Integrated Issue Resolution Status Report

**U.S. Nuclear Regulatory Commission
Office of Nuclear Materials Safety and Safeguards
Washington, DC 20555-0001**

Integrated Issue Resolution Status Report

Manuscript Completed: April 2002
Date Published: July 2002

Figure 2.1.6-3. Modified DOE Preclosure Classification Criteria⁹

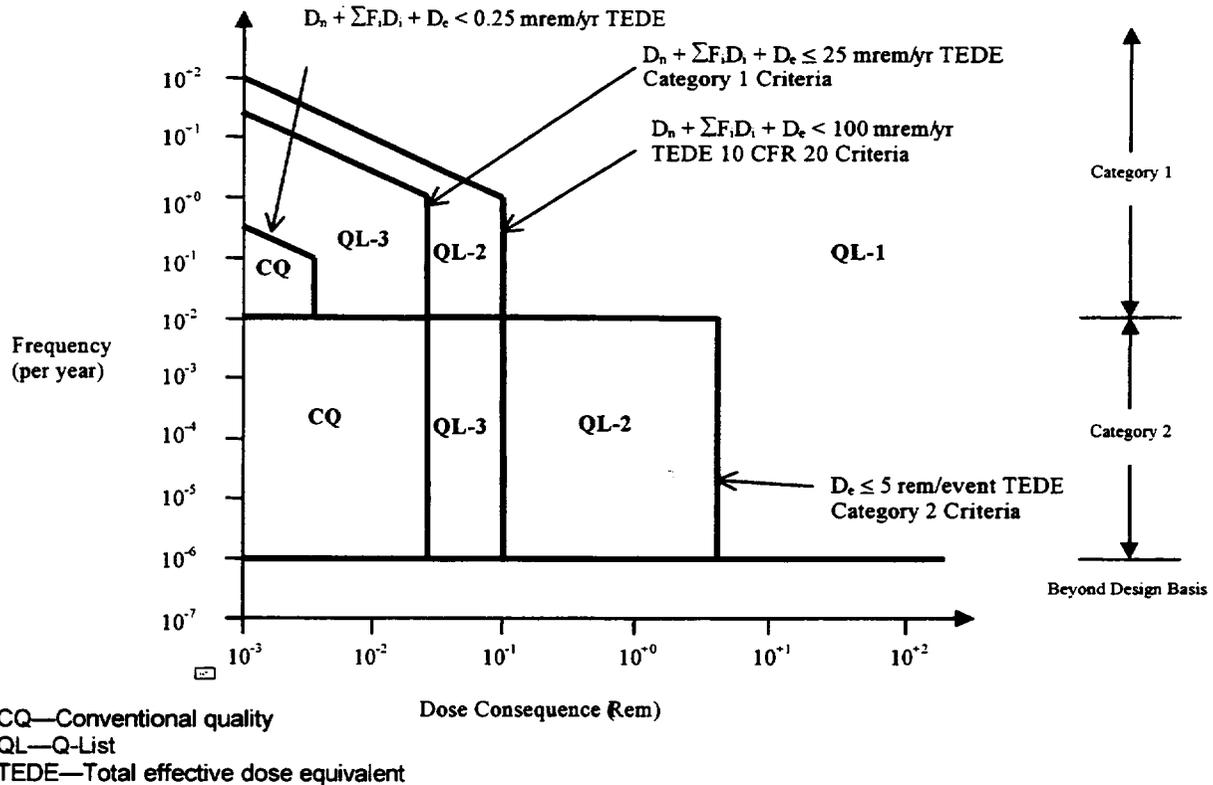
release in the annualized dose expression and also shows the risk measures for Quality Levels 2 and 3 and conventional quality for Categories 1 and 2 event sequences. DOE stated it is revising the procedure QAP-2-3 (CRWMS M&O, 1999c) and developing a desktop reference that will provide a clear description of the categorization process, screening criteria, and take-away analysis. Staff agreed with the overall DOE approach to categorize structures, systems, and components important to safety. Staff will review the revised procedure QAP-2-3 and the desktop reference document when it becomes available.

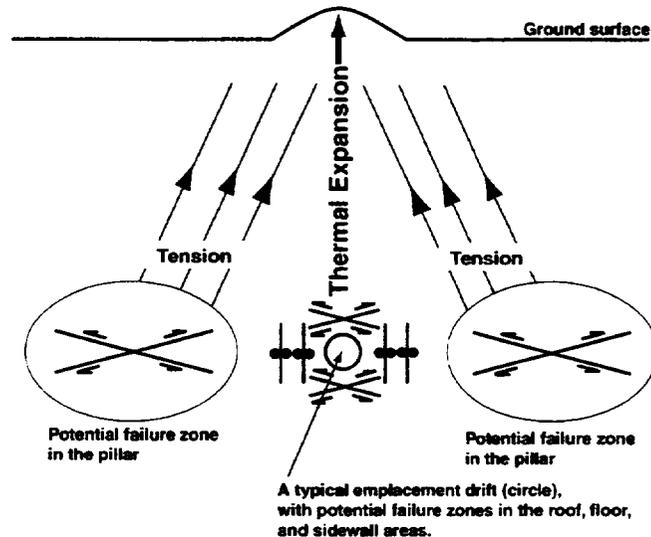
As shown in Figure 2.1.7-1 (Ofoegbu, 2001), the emplacement geometry will have a strong influence on the nature and magnitude of thermally induced stress and the associated mechanism and distribution of potential rock failure. Two features of the emplacement geometry that influence the anticipated thermal-mechanical behavior are the large lateral extent of the emplacement-drift array relative to the vertical extent and the closeness of the drift array to the ground surface relative to the distance to other boundaries of the host rock mass (CRWMS M&O, 2000m). For a typical drift within the emplacement-drift array, thermal expansion of the surrounding rock would be fully suppressed laterally, but a limited amount of upward expansion can occur because of free movement at the ground surface

(Figure 2.1.7-1). Consequently, the anticipated horizontal component of thermal stress is much higher than the vertical component. The only exception is in areas close to the sidewall of the drift openings where the vertical component of thermal stress would be higher than the drift-normal horizontal component because of the closeness of a traction-free boundary. The upward expansion of the heated zones around a drift would impose an upward pull on cooler areas in the pillars, resulting in thermally induced tension in the vertical direction (Figure 2.1.7-1). The vertical component of rock stress near the pillar centers would, thus, be expected to decrease and may occasionally be tensile. These stress conditions, which depend only on the emplacement geometry, favor the development of potential zones of rock failure (by fracture slip) through the mechanisms illustrated in Figure 2.1.7-1 (i.e., reverse-faulting style in the roof and floor areas of the drifts and in the pillars, and strike-slip or normal-faulting styles near the drift sidewalls). The magnitudes of the induced stresses and whether such stresses

As illustrated in Figure 2.1.7-1 (Ofoegbu, 2001) and discussed in the foregoing paragraph, the effect of geometry on thermally induced stress depends to a large extent on the location of a mechanically free boundary, such as the ground surface. The topography of Yucca Mountain (e.g., Section 2.1.1) is such that the distance to the closest free surface and the orientation of the direct line from an emplacement drift to the free surface vary over the proposed emplacement area. For example, a typical east-west vertical section through Yucca Mountain (e.g., DOE, 2001a, Figure 1-10) indicates that the direct line from the emplacement area to the closest free surface would be inclined approximately 45 degrees to the vertical in the west (where the closest free surface is the Solitario Canyon) but would be nearly vertical in the east. Therefore, the orientation of the thermally induced tension in Figure 2.1.7-1 would vary over the emplacement area. For this reason, the topography of Yucca Mountain may have an important effect on the distributions of thermally induced stress and potential failure zones within the proposed emplacement area.
